Project	IEEE 802.16 Broadband Wireless Access Working Group < http://ieee802.org/16 >	
Title	Proposed SDD Text for UL Control	
Date Submitted	2008-09-17	
Source(s)	Dongsheng Yu, Hosein Nikopourdeilami, Mo-Han Fong, Jun Yuan, Sophie Vrzic, Robert Novak, Kathiravetpillai Sivanesan Nortel Networks	Email: dongshengyu@nortel.com mhfong@nortel.com
Re:	SDD Session 56 Cleanup, Call for PHY details; in response to the TGM Call for Contributions and Comments 802.16m-08/033 for Session 57	
Abstract	This contribution proposes SDD text for UL Control channel and sounding channel	
Purpose	For discussion and approval into TGM SDD text	
Notice	<i>This document does not represent the agreed views of the IEEE 802.16 Working Group or any of its subgroups. It represents only the views of the participants listed in the "Source(s)" field above. It is offered as a basis for discussion. It is not binding on the contributor(s), who reserve(s) the right to add, amend or withdraw material contained herein.</i>

Proposed SDD Text for UL Control Structure

Figure 1 UL control tile: 6x3 vs 3x6 at 240km/h

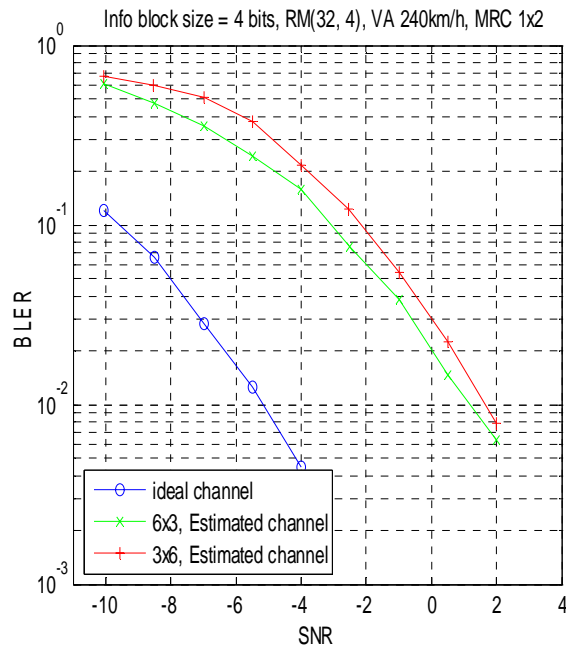
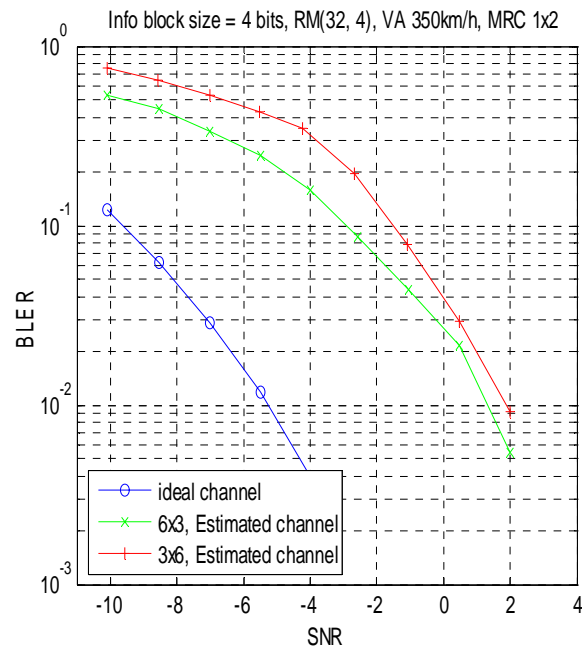
For evaluating performance different between 6x3 tile and 3x6 tile, we choose Reed-Muller code RM(5, 1) concatenated by repetition 2 code as encoding sequence. Each encoded binary sequence is modulated by QPSK and mapped to two control tiles, either 3x6 tile or 6x3 tile. Simulation results with coherent detection show 6x3 tile perform better than 3x6 tile at high speed of 240km/h and 350km/h due to 6x3 span less OFM symbols in time direction.

Figure 3 UL control tile size + sequence comparison

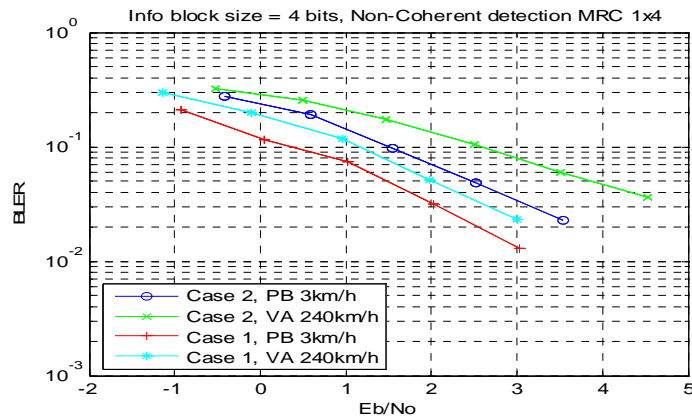
From Figure 3, It can be seen that orthogonal sequence based on RM code in case 1 outperform semi-orthogonal sequence in case 2. Case 2 has more diversity while case 1 has long sequence. Also note that pilot assisted non-coherent detection is possible for case 1.

On the other hand, by comparing performance under different mobile speeds, it can be seen that 6x3 tile is more robust than 2x6 tile. This is because non-coherent detection depends on the good correlation of sequences and variation among more symbols has more negative impact when the tile span more symbols

It is recommended that 6x3 tile is used as UL control tile and Reed-Muller code based sequence should be used for encoding sequence.

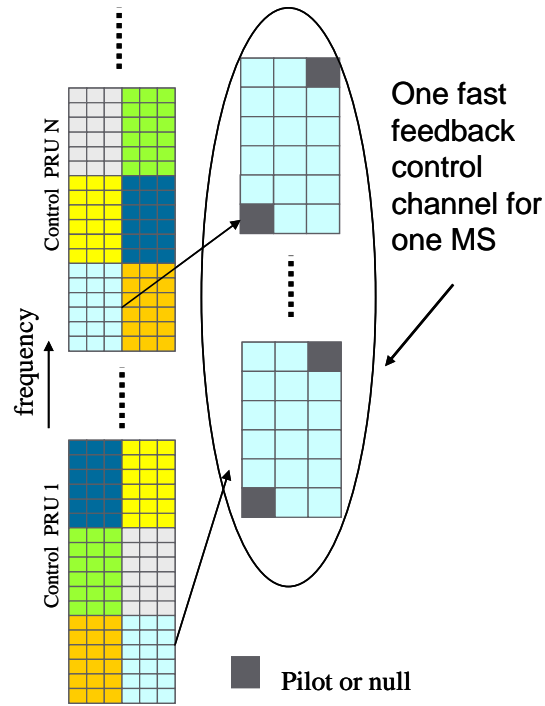
UL fast feedback channel consists of 2/4/8 control tiles, which are distributed in multiple control PRUs. Each UL fast feedback channel is occupied by one MS. Control tile and pilot for fast feedback channel is shown in the following figure. Control tiles in one control PRU are shared by different UL control channels.

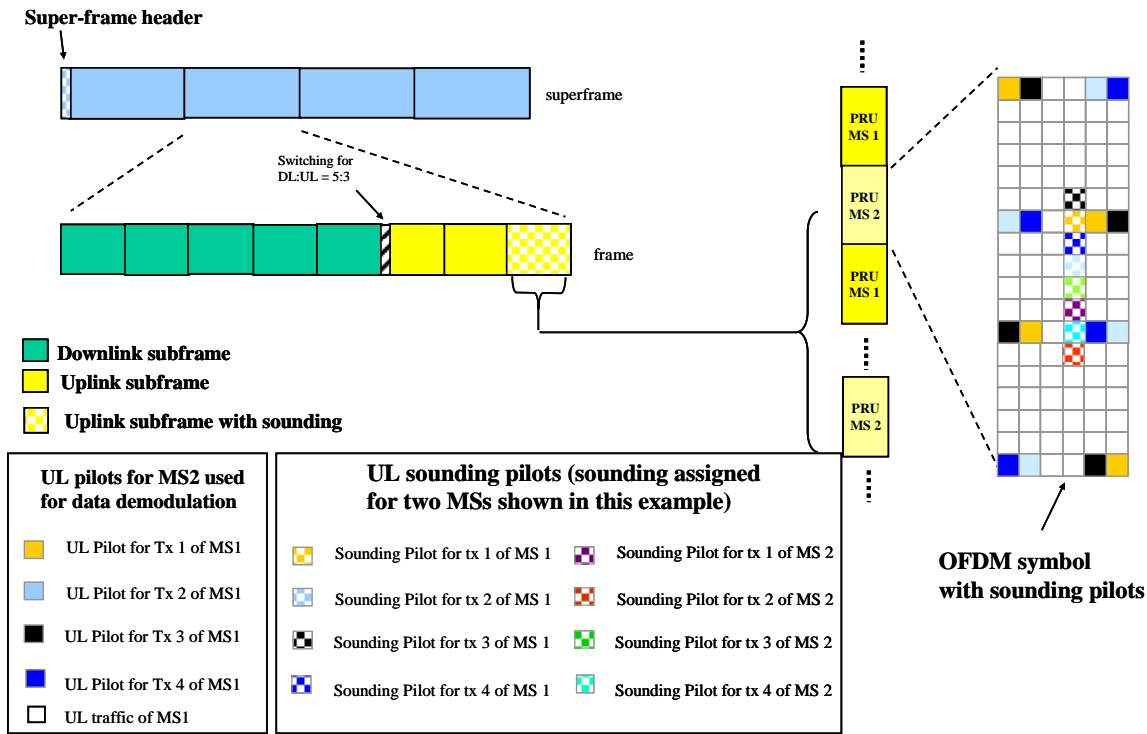
Sounding from single or multiple antennas and multiple users are supported to provide full MIMO channel information for DL transmission. Power allocation, sounding sequence design and mapping to subcarriers is TBD. An example of subcarrier mapping is shown in the following figure:
